SUBJECT: ISSUANCE OF AMENDMENT NO. 3 TO LICENSE NO. DPR-75 - SALEM NUCLEAR
GENERATING STATION, UNIT NO. 2

SALEM NUCLEAR GENERATING STATION, UNITS NO. 2

Amendment No. 3
License No. DPR-75

SAFETY EVALUATION
BY THE OFFICE OF NUCLEAR REACTOR REGULATION
RELATED TO AMENDMENT NO. 3
TO FACILITY OPERATING LICENSE NO. DPR-75
PUBLIC SERVICE ELECTRIC AND GAS COMPANY
SALEM GENERATING STATION, UNIT NO. 2
DOCKET NO: 50-311

FIGURE 6.2.2 FACILITY ORGANIZATION - SALEM GENERATING STATION

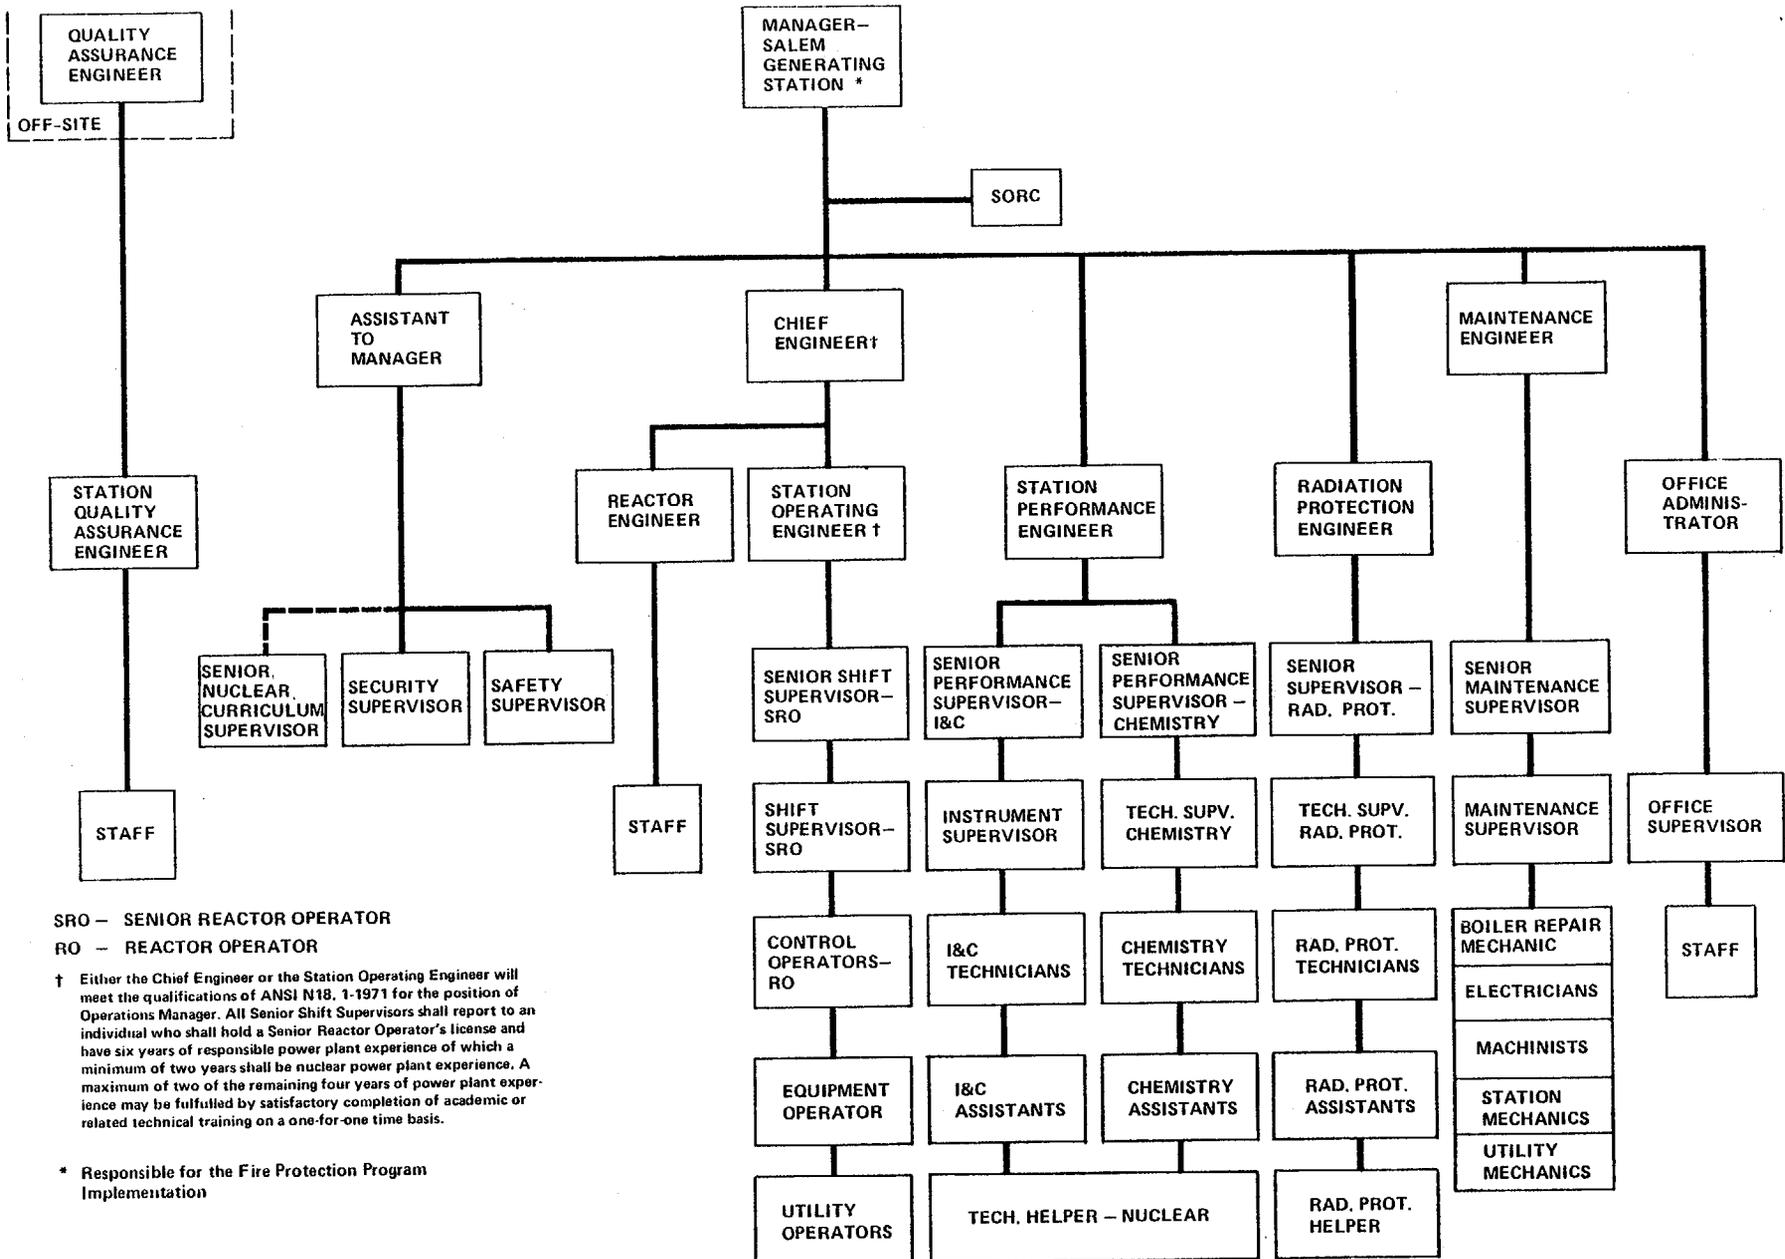
The licensee has proposed significant changes to the Salem Radiation Protection organization. PSE&G changes provide for the separation of the radiation protection function from the Performance Department and formation of a new Radiation Protection Department. This new department will be headed by a Radiation Protection Engineer who will report directly to the station Manager. It will have a Senior Supervisor - Radiation Protection (who will act as backup to the Radiation Protection Engineer), Technical Supervisors, Technicians and Technical Assistants, all of whom will be devoted to the function of radiation protection. The remainder of the Performance Department will be modified to split the Technical Assistants such that they are devoted to either the instrumentation and controls function or the chemistry function.

The licensee has proposed significant changes to the Salem Radiation Protection organization. PSE&G changes provide for the separation of the radiation protection function from the Performance Department and formation of a new Radiation Protection Department. This new department will be headed by a Radiation Protection Engineer who will report directly to the station Manager. It will have a Senior Supervisor - Radiation Protection (who will act as backup to the Radiation Protection Engineer), Technical Supervisors, Technicians and Technical Assistants, all of whom will be devoted to the function of radiation protection. The remainder of the Performance Department will be modified to split the Technical Assistants such that they are devoted to either the instrumentation and controls function or the chemistry function.

1. The Radiation Protection Engineer (RPE - equivalent to the Radiation Protection Manager) reports directly to the Station Manager, independent of operational, technical or administrative groups. The RPE is a required member of the Station Operations Review Committee (SORC). Staff qualifications require that the RPE meet or exceed the recommendations of Regulatory Guide 1.8.

2. The newly formed Radiation Protection Department has an independent radiation protection function at all levels, and is separate from such functions as chemistry. A backup to the RPE, the Senior Supervisor-Radiation Protection has been designated. All Technical Supervisors, Technicians and Technical Assistants within the department are devoted to the radiation protection function.
